Permittee PacificCorp	Mine Name Trail Mountain	Amendment # ACT 10051009-96C	Date Received / 6-28-96 via US Mail
Proposal: Yard Drainage			
Description: The modifications will aid in the overall surface drainage of the Trail Mtn Yard.

**TRAIL MOUNTAIN MINE
AMENDMENT TO YARD DRAINAGE**

Re: Yard Drainage, PacifiCorp, Trail Mountain Mine, ACT/015/009-96C, Folder #2, Emery County, Utah

RE: Drainage Amendment, Trail Mountain Mine, PacifiCorp, ACT/015/009-96C, File #2, Emery County, Utah

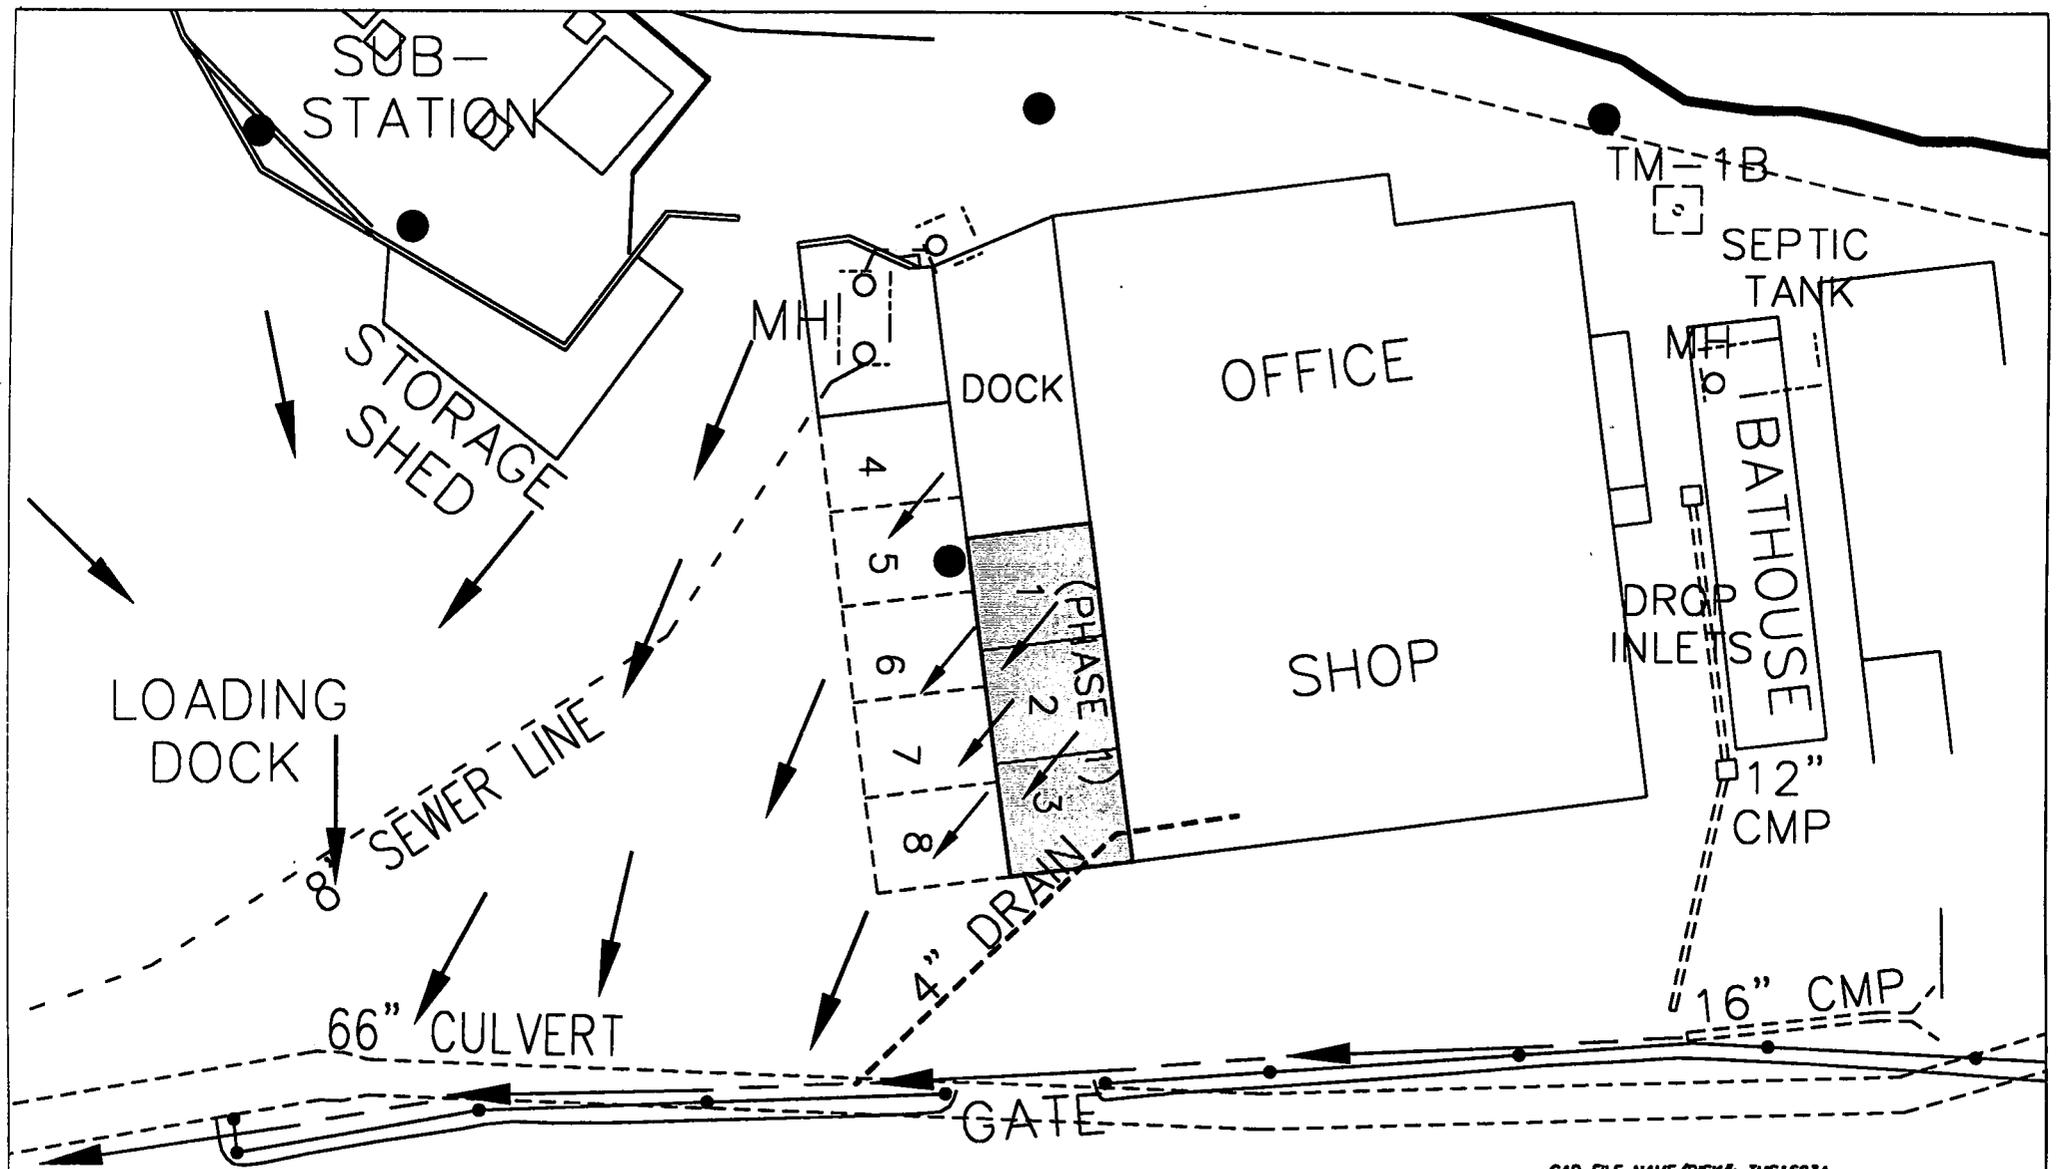
PacifiCorp has proposed drainage modification to the Trail Mountain Mine yard. The modifications include installation of a drop inlet into CMP #1 and a new CMP #4 with drop inlet. CMP #4 will discharge into CMP #1. A temporary culvert (CMP #5) will be installed to convey water generated at the transfer building.

The proposed drainages changes are all temporary and diverting of miscellaneous flow. The 10-year, 6-hour storm event is required by the regulations for their design. PacifiCorp has designed to culverts and inlets to convey the 100-year, 6-hour which is much more conservative. The culverts sizes chosen will pass the design storms will much space to spare.

The operator has met the requirements of operational diversion design regulation in designing CMP #1, 4 and 5 for the 100-year, 6-hour storm event.

This amendment should be approved for construction.
